Massachusetts Port Authority
One Harborside Drive, Suite 200S
East Boston, MA 02128-2090
Telephone (617) 568-5950
www.massport.com

December 22, 2016

Subject: 115 Winthrop Square ENF (EEA #15610)

Boston - Logan International Airport
Composite of Critical Airspace Surfaces

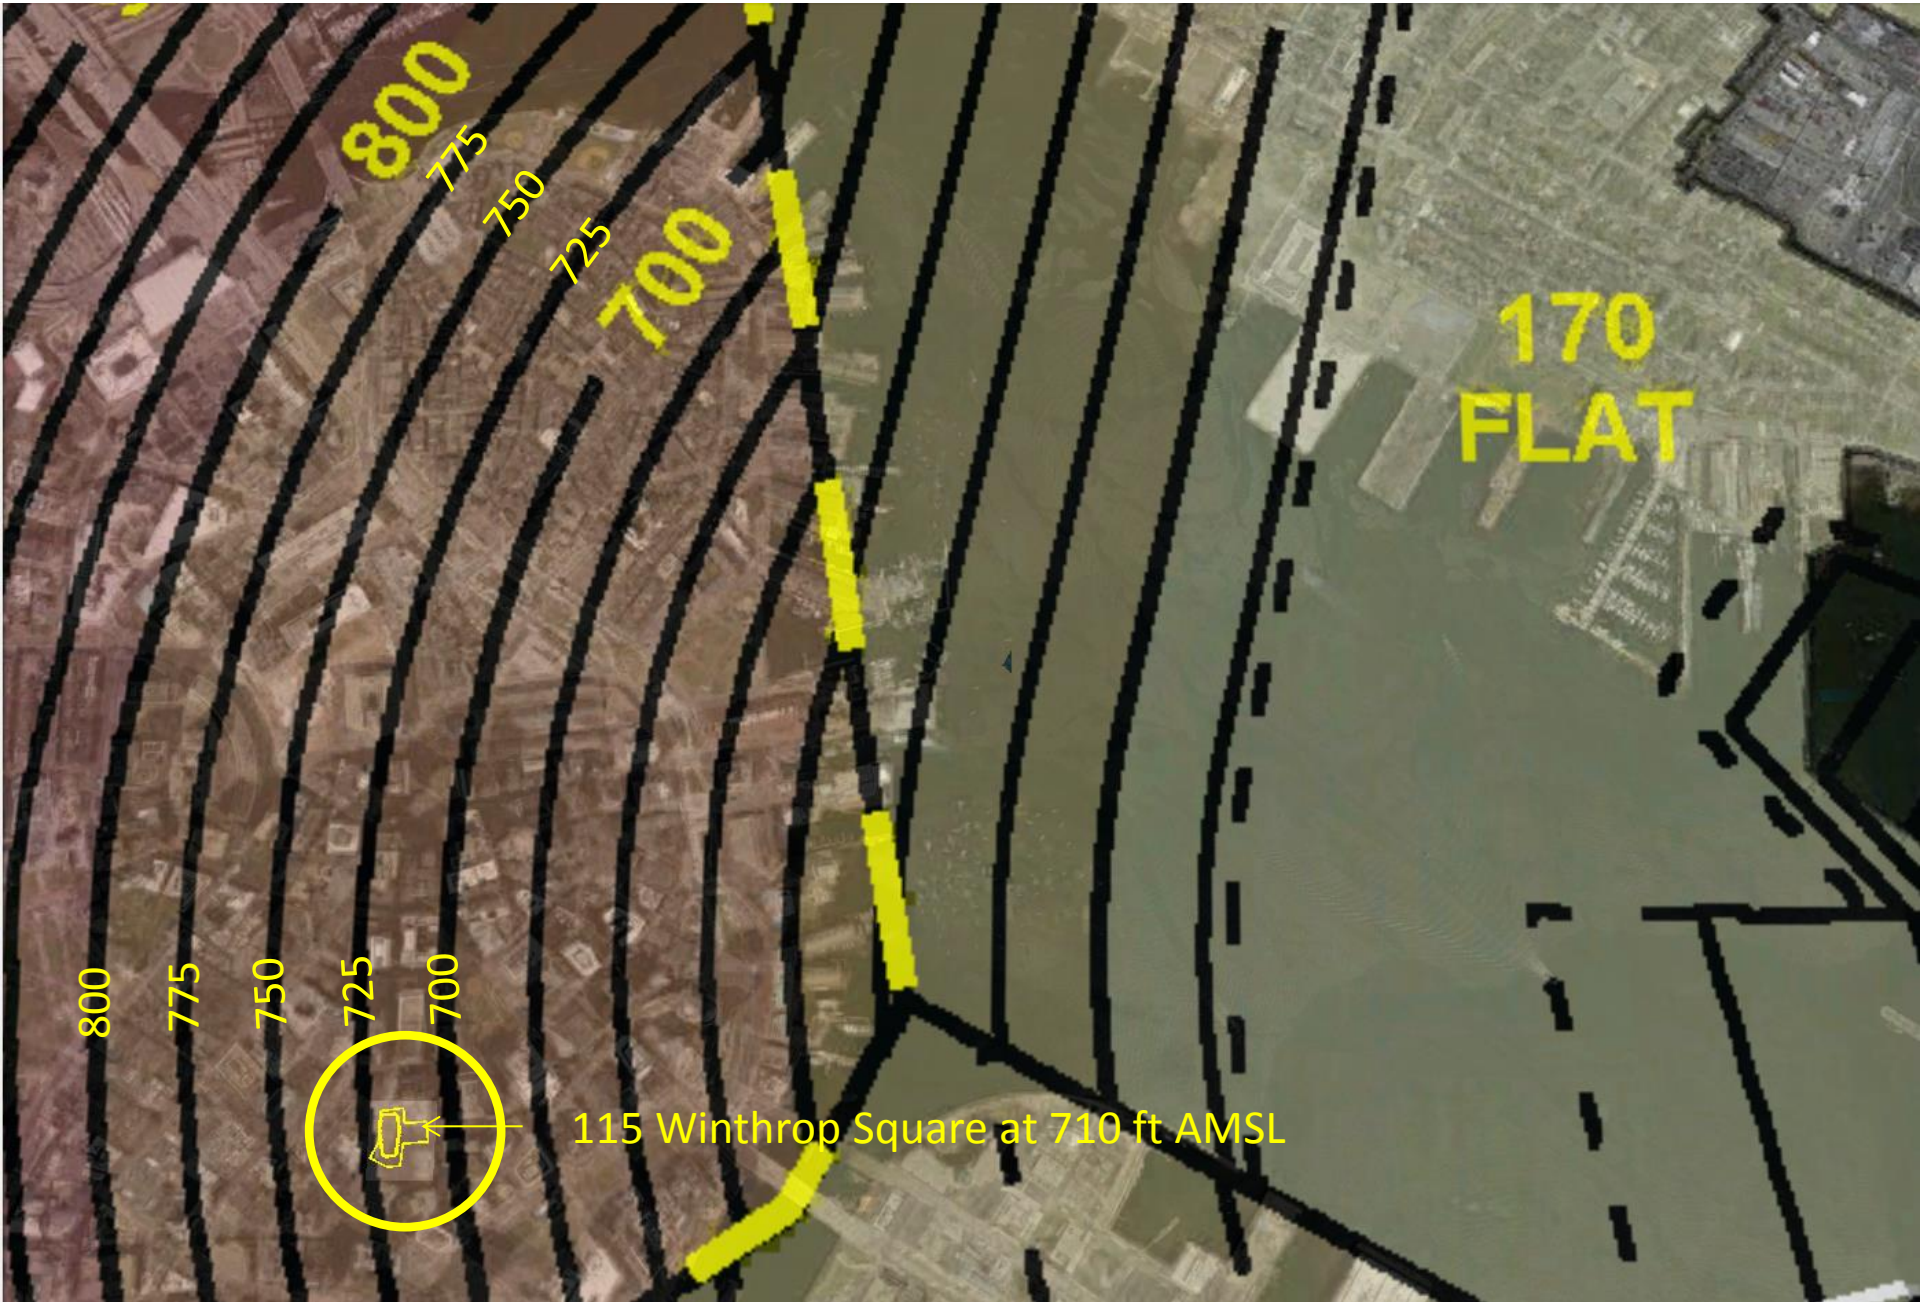
A building height greater than 710 feet MSL at the 115 Winthrop Square location would have the following impacts on Logan Airport operations:

- **Significantly impact Runway 27 Departures.** The proposed structure will penetrate the Federal Aviation Administration's (FAA) existing Runway 27 departure corridor. A building taller than 710' AMSL at this location would significantly reduce the capacity of the remaining airspace.
- **Lead airlines to shift departures from Runway 27 to Runway 33L.** This would reduce the efficiency of flight departure configurations in a Northwest wind condition
- **Shift overflights and associated noise** from communities south of Boston to communities west and north of Boston
- **Restrict existing FAA Circle-to-Land operations** to all runways, reducing flexibility of Logan FAA Air Traffic Control Tower to manage close-in flights

115 Winthrop Square overlay on Logan Airspace Map

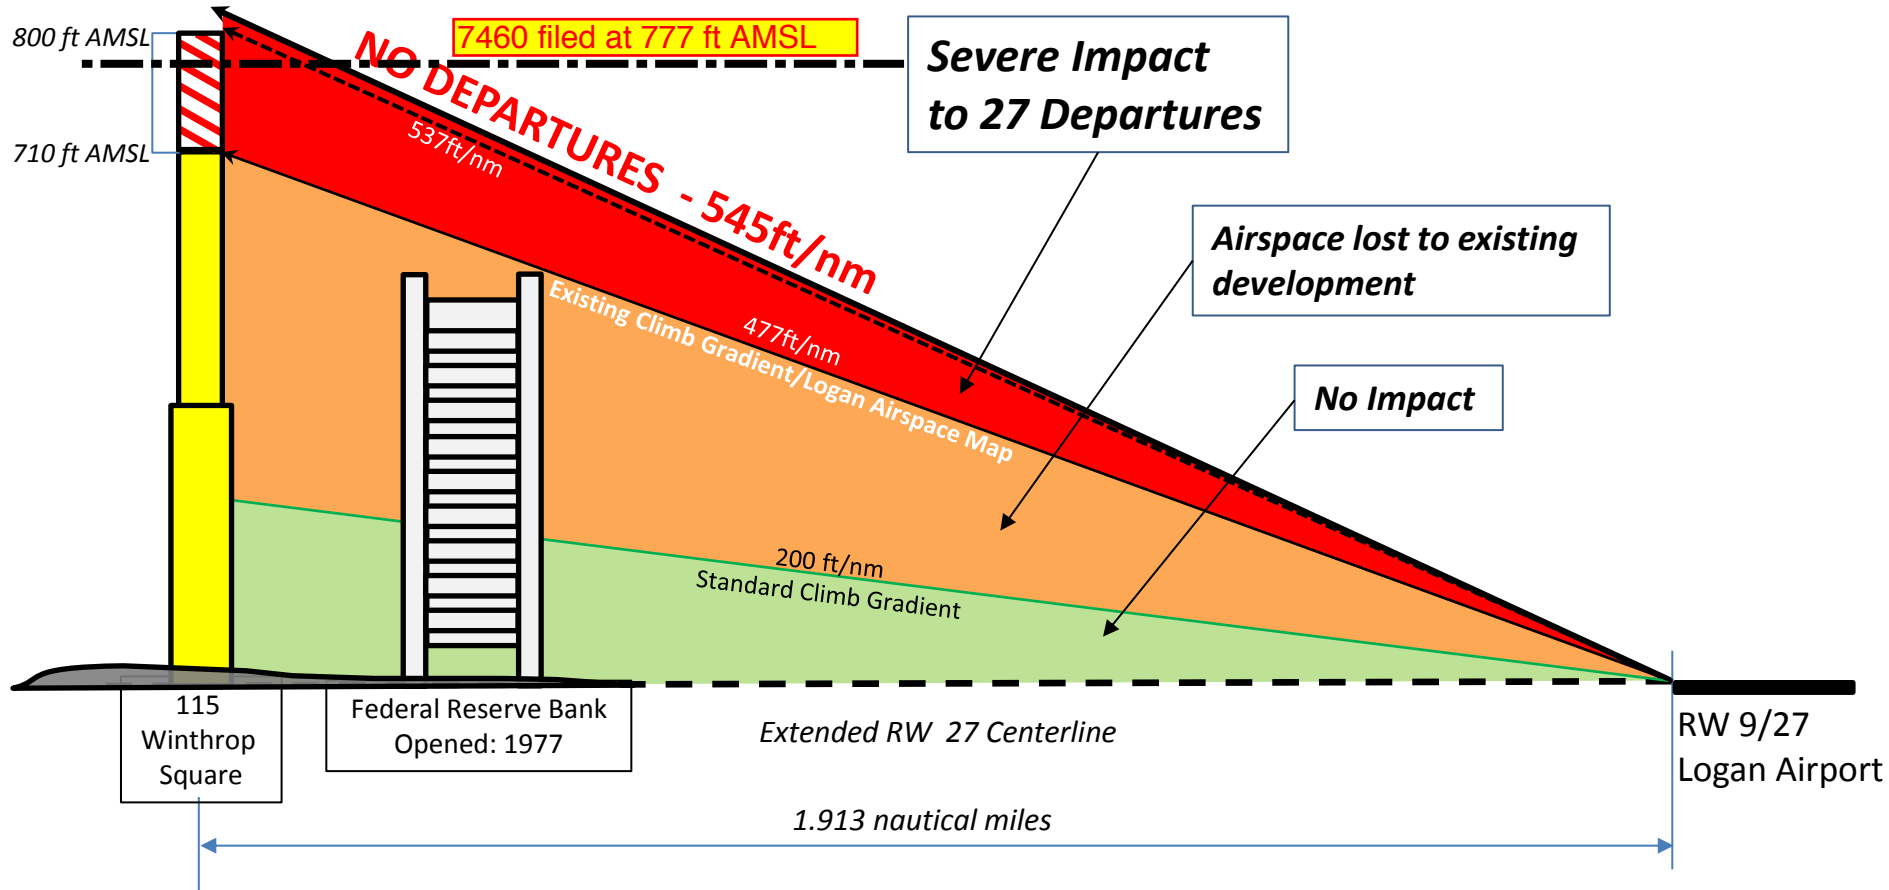
Therefore, Massport urges MCAF Winthrop LLC to explore alternative designs that meet the same project goals without exceeding the height of the 710 feet AMSL that would cause significant adverse Logan Airport operational and noise impacts.

RW 27 climb gradient is already compromised more than twice the standard. Building taller than 710' AMSL will significantly degrade remaining airspace
